## Planning Application 22/06241/FUL - 28 Dick Place EH9 2JJ

### OBJECTION from Grange Association

25 January 2023

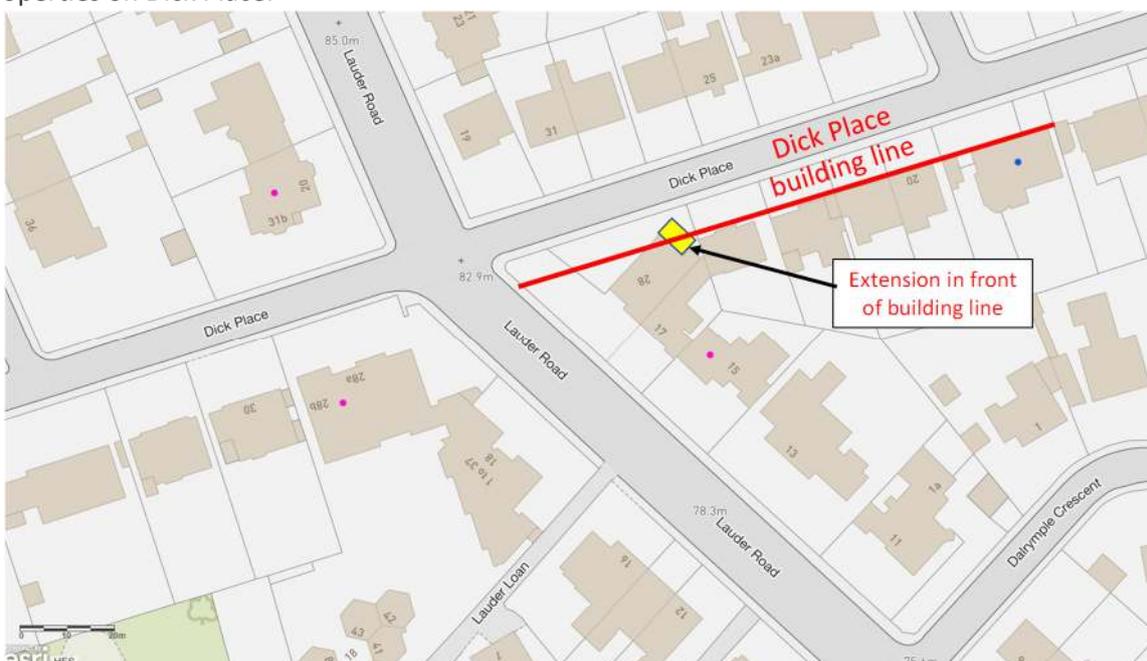
The existing house has an unusual orientation on this corner site, angled from the building line of Dick Place. The building occupies almost the entire width of the site at its rear, leaving just a very modest front garden for visual relief. The proposed additional ground floor extension would exacerbate this effect, such that the property's frontage would almost entirely span the site, creating a terracing effect. This would be contrary to the character of the Grange set out in the Grange Conservation Area Character Appraisal, which praises the gaps between properties (page 15):

The property already marginally breaches the building line of the villas on the South side of Dick Place. The proposed ground floor extension would come even further towards the road and the boundary, with the northeast corner within 3m of the street boundary, much closer than the ~8m of the other properties on Dick Place.

The proposed balcony to the East of the first floor extension would present a gross intrusion to the privacy of neighbours. By virtue of the orientation and location of the property, this balcony would provide a vantage point for viewing not only the neighbouring properties in Dick Place, but a line of gardens down the East side of Lauder Road, infringing the privacy of many neighbours.

The proposed windows in the extensions are to be timber-framed, which we welcome. However, the proposed design is unsympathetic to the fenestration of the existing house, which has classic ‘six-over-six’ styles for the sashes. The proposed opening method is also not specified on the drawings. We request that any grant of permission be conditional on the new windows matching the sash and case opening style with the six-over-six fenestration, even if only with false astragals.

The front elevations of the extensions are proposed to be sandstone, which we welcome. However, the rear of the first floor extension is shown as “white render” on the drawings. We query whether this is a drawing error. White render would be wholly inappropriate for this elevation which will be very visible from the rear gardens of many neighbours in Lauder Road. We request that this material specification be changed to sandstone.
